Wisconsin Department of Transportation

NOTICE TO ALL CONTRACTORS:

Proposal #07: 2030-14-70, WISC 2018 086
108th St, City of West Allis
Hank Aaron State Trail, B-40-107/108
STH 100
Milwaukee County

This is Addendum No. 01, which provides for the following:

Addendum No. 01
 ID 2030-14-70
 Revised Sheet 322
 February 6, 2018

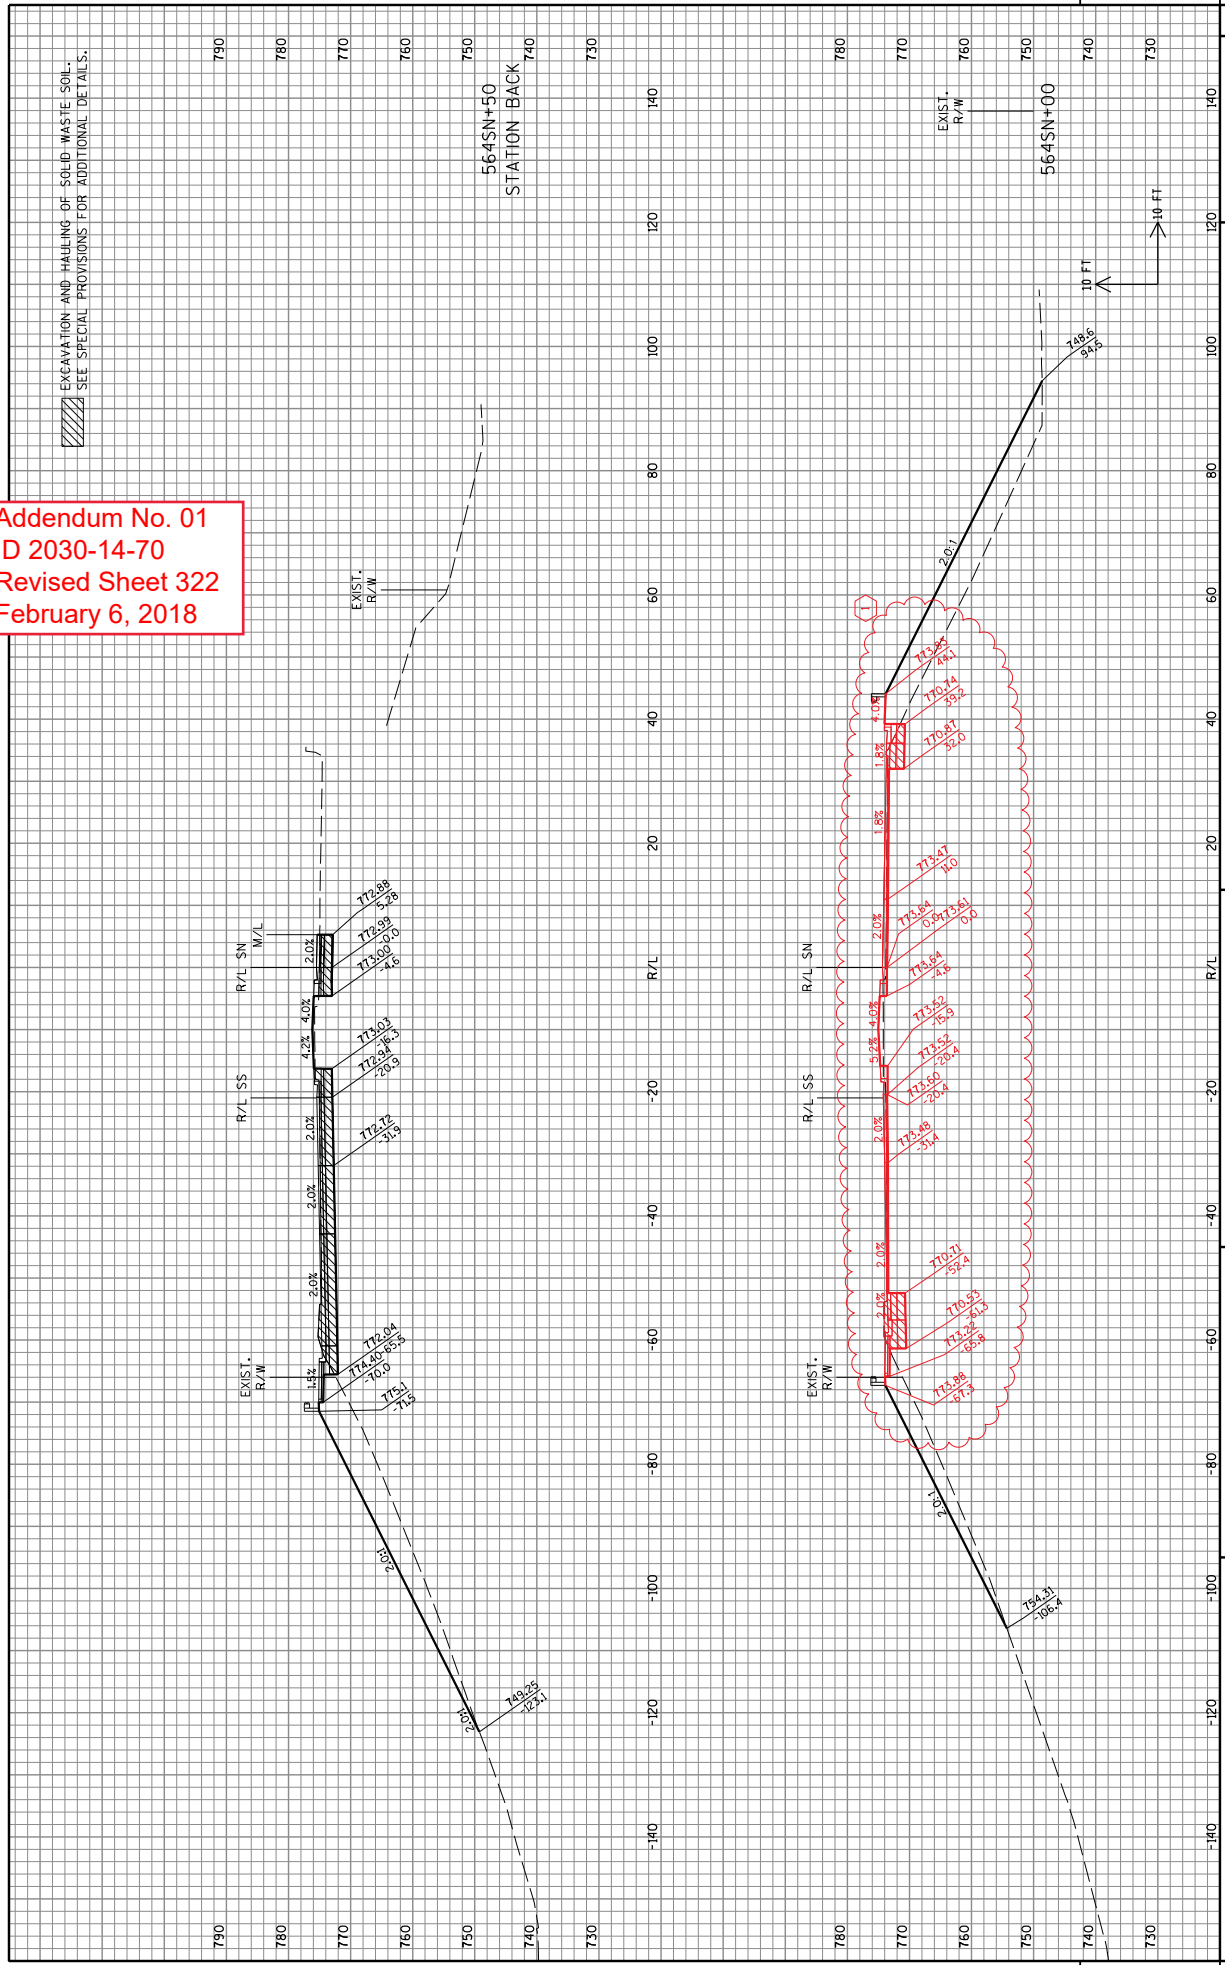
319	Revised Earthwork Data
320	Revised Pavement Structure and Reconstruction Limits
321	Revised Pavement Structure and Reconstruction Limits
322	Revised Pavement Structure and Reconstruction Limits
